HISTORIC LANDMARK COMMISSION
APPLICATION FOR A CERTIFICATE OF APPROPRIATENESS
DECEMBER 17, 2021
C14H-2009-0029; HR-2021-148730
DAVIS HOUSE
1600 GASTON AVE.

PROPOSAL

Construct a second-story addition over the garage and replace a window.

A-1

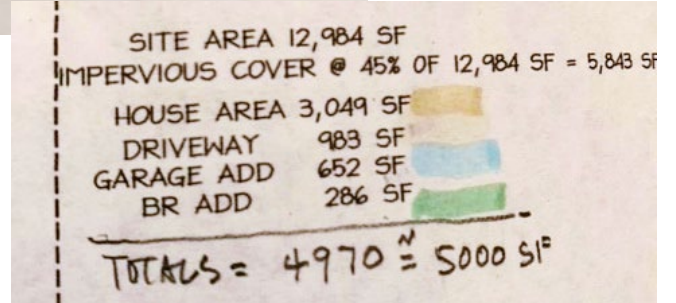
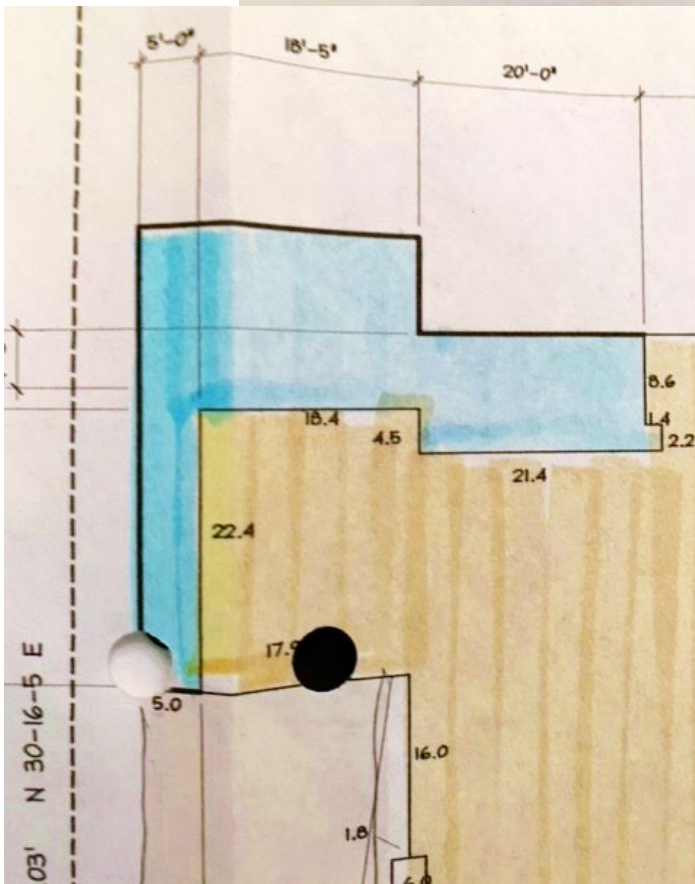
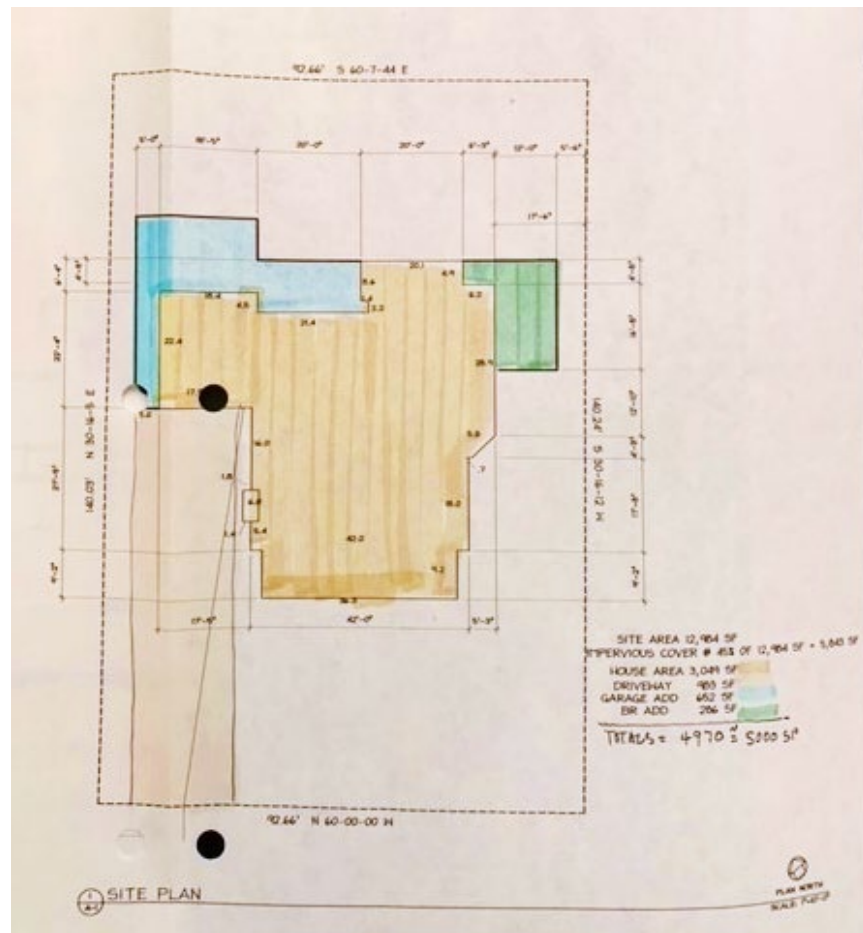
Building permit records indicate the garage was enlarged and rebuilt when other additions were made to the house in 2004, before the house became a landmark. No additional drawings, such as a demolition plan or elevation showing the changes to the garage, are currently available in permit records. Note the entire garage roof was replaced.

Site plan (overall sheet and enlargements) showing footprint of 2004 garage addition, courtesy of applicant.
